BC BUILDING CODE INTERPRETATION COMMITTEE

File No: 18-0063 R1

INTERPRETATION

Interpretation Date:	July 21, 2020 (<i>Revised 2025 08 01</i>)
Building Code Edition:	BC Building Code 2018
Subject:	Location of Smoke Detectors to Close Smoke Dampers
Keywords:	Smoke detectors, motorized smoke dampers
Building Code Reference(s):	3.1.8.11.(3)

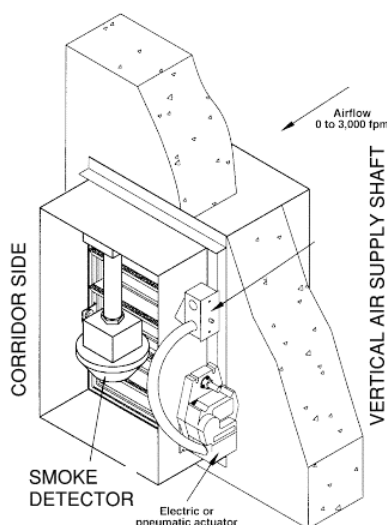
There are smoke/fire dampers that are provided with an integral smoke detector, so those would be another option since they comply with Clause 3.1.8.11.(3)(b) provided that the smoke detector is located on the corridor side of the smoke/fire damper. Note that Sentence 3.1.8.11.(2) allows the combination smoke/fire damper to be offset from the fire separation wall by 610 mm to accommodate the smoke detector on the downstream side of the damper. See illustration below.

See diagrams on Page 4.

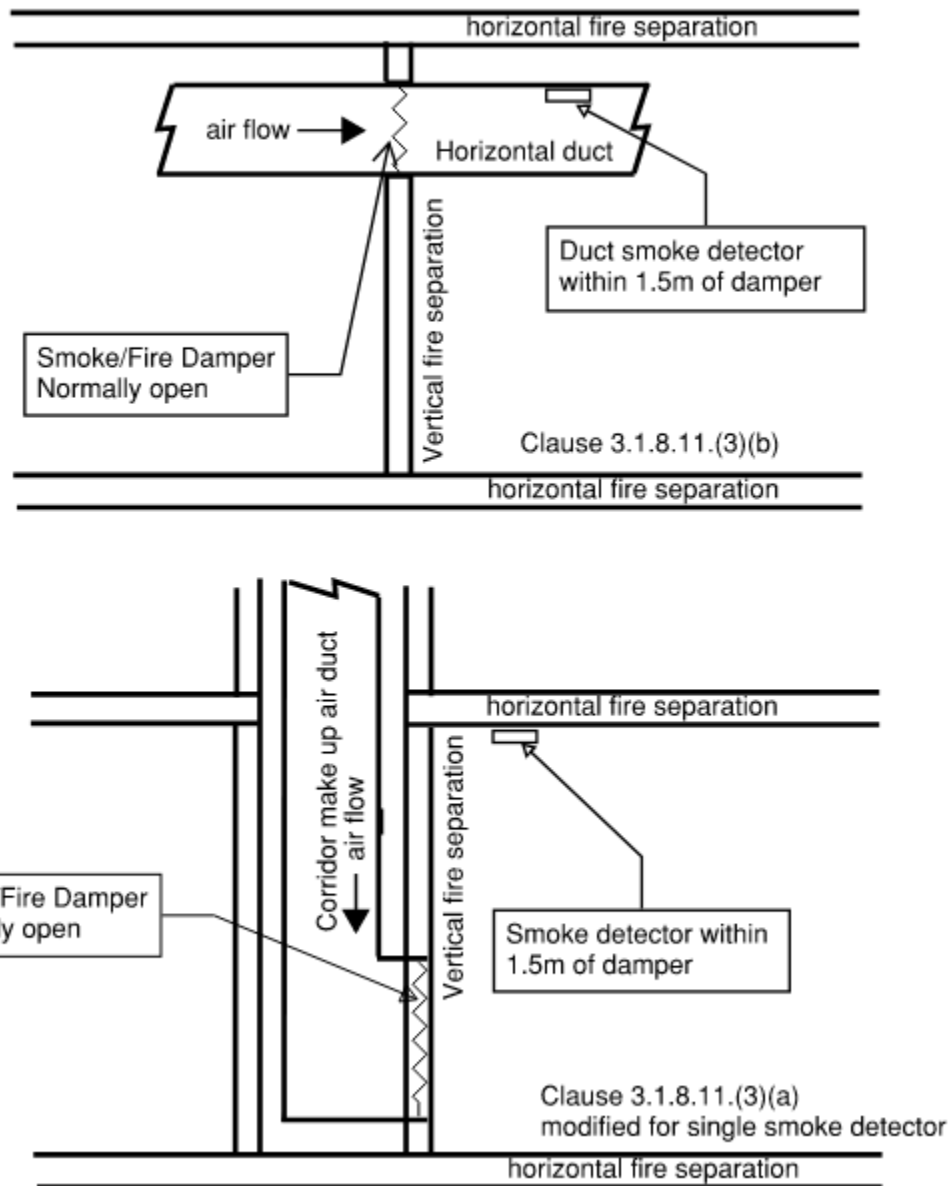
Since the intent of Sentence 3.1.8.11.(3) is to prevent the movement of smoke from one fire compartment that contains a fire to another fire compartment, the best location for the smoke detector that closes the smoke/fire damper is on one side of the smoke/fire damper on the ceiling of the corridor within 1.5m of the smoke/fire damper. It is not logical to also install a fire damper on the other side of the smoke/fire damper as suggested by Clause 3.1.8.11.(3)(a) because the only place to install it would be within the vertical duct shaft. A smoke detector within the vertical duct shaft could be activated by a fire on multiple floor levels, so it may close the wrong damper.

It could be interpreted that installing the smoke detector on the ceiling of the corridor meets the intent of Clause 3.1.8.11.(3)(b) since it is located downstream of the smoke damper. The only difference is that it is not located within a duct because there is no duct which is downstream of the smoke damper.

The BC Building Code Interpretation Committee has sent a request to NRC to amend the wording of Sentence 3.1.8.11.(3) to allow a single smoke detector on the ceiling of the corridor which is within 1.5m of an air transfer louvre which is connected to a vertical duct shaft.

1. Yes (although this is the best location, a code change is required)
